**TSG-RAN Meeting #13  
Beijing, China, 18 - 21 September 2001**

**RP-010547**

**Title: Agreed CRs (Release '99 and Rel-4 category A) to TS 25.331 (4)**

**Source: TSG-RAN WG2**

Figure 20: Signalling connection release ~~request~~indication procedure, normal case

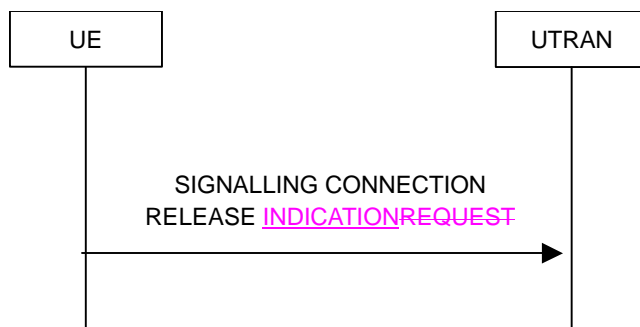
**Reason for change:** ⌘ 1 - The Signalling Connection Release Request procedure can result in the UE RRC and UE MM layers being out of sync with regard to the currently established signalling connections. This can lead to ambiguity about when the Initial Direct Transfer and Direct Transfer messages are used.

**Summary of change:** ⌘ 1 - Section 8.1.4.2 is changed so that the RRC layer considers the signalling connection to be released when the signalling connection release request procedure is initiated. This ensures that UE RRC and UE MM layers maintain synchronisation. The name of the Signalling Connection Release Request message is changed to a more appropriate Signalling Connection Release Indication.

- set the IE "CN Domain Identity" to the value indicated by the upper layers. The value of the IE indicates the CN domain whose associated signalling connection the upper layers are requestindicationing to be released;
- remove the signalling connection with the identity indicated by upper layers from the variable ESTABLISHED\_SIGNALLING\_CONNECTIONS;
- transmit a SIGNALLING CONNECTION RELEASE REQUESTINDICATION message on DCCH using AM RLC.
